ADVISORY WIRE

REFERENCE NO:	AW700-24-0370, Rev. 2	INFORMATION TYPE:	Maintenance
ATA:	24-25	EFFECTIVITY:	Global Express / XRS (9002 - 9312, 9314 - 9380, 9384 - 9429)
SUBJECT:	Variable Frequency Generator (VFG) #4 Feeder Cable Chafing		Global 5000 (9127 to 9383, 9389 to 9400, 9404 to 9431 and 9998) Global 5000 feat. Vision Flight Deck (9386, 9401, 9445 - 9492) Global 6000 (9313, 9381, 9432 -9492)

Picture 1: Final installation without the existing white sleeve

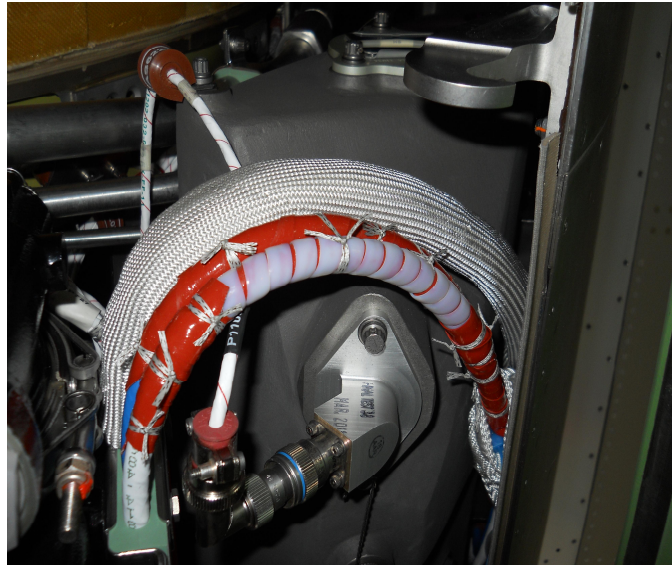
Bombardier has conducted an investigation which has revealed an inconsistency in the length of VFG-connecting cables during the manufacturing process. This variability could slightly modify the cables' routing path, resulting in a clearance reduction between the VFG cables and the cowling door. To rectify this situation, Bombardier released an In-Service Modsum (Ref. 1.1) which consists of installing silicone tape and Spirap in addition to the existing white protection sleeves (see picture 1). The four cables will then be attached together with lacing cord in order to maximize the clearance between the cables and the cowling door (see picture 2).

To eliminate the potential chafing condition during production, the cables' installation process has been reviewed and modified in order to tighten the cables' length tolerances. The new tolerances have been introduced in production at aircraft 9493.
